# Ballard Pump Station

## Project Description

## Meeting Summary

Figure 3: Landscape site plan, site circulation, and urban tree farm

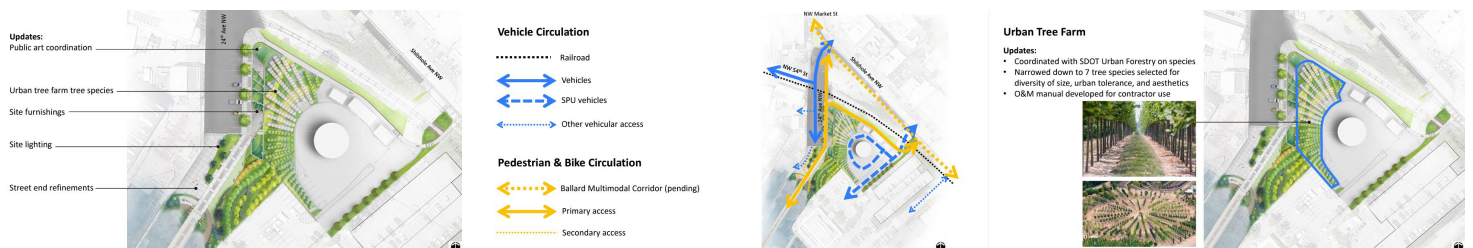
Commissioners discussed whether the fence was needed to protect the trees considering they were slated to be used in planting strips and other urban places where they would need to be robust. Commissioners suggested the team consider again whether the fence could be moved back (see Figure 7). Acknowledging that trees need protection when young, they asked that the fence at least be limited to six feet high. If mesh is used, they asked the team to consider turning diamond/diagonal to perpendicular/vertical.

Commissioners supported the idea that an urban tree farm was an interim use. They did have thoughts on the fencing of this area, as described above under Architecture and Fencing.

Figure 4: Public art

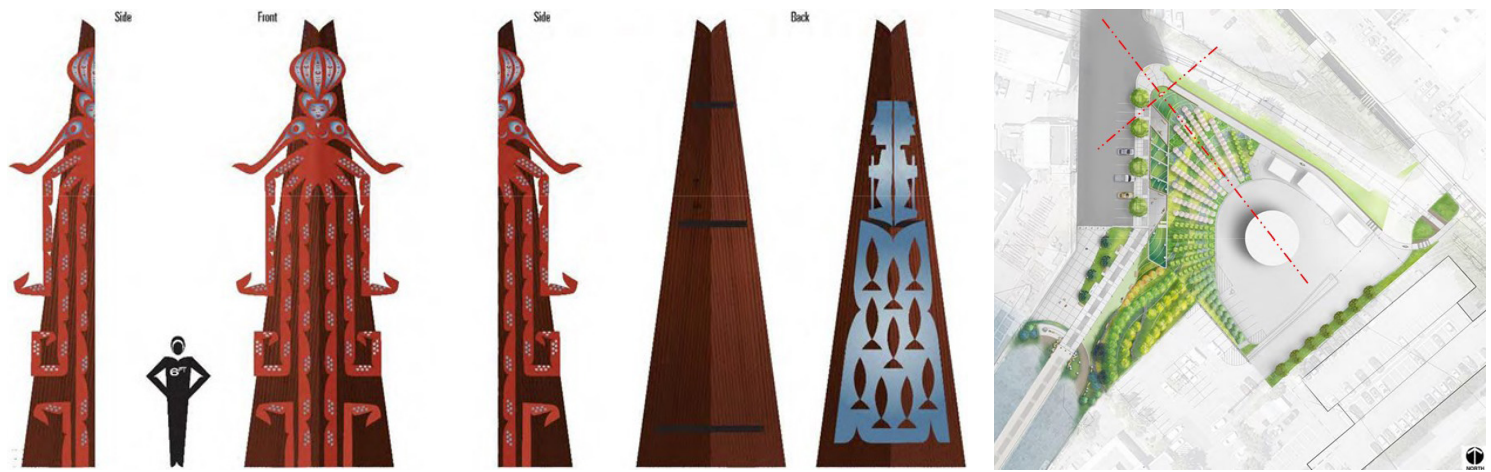
As at the last meeting, the Commissioners expressed excitement and support for the art. They also supported the lighting design (see Figure 8). They recommended that care be taken with plans for how the lighting is orchestrated. The lighting should enhance rather than distract from or overwhelm the sculpture itself, and respect both the object and its location.
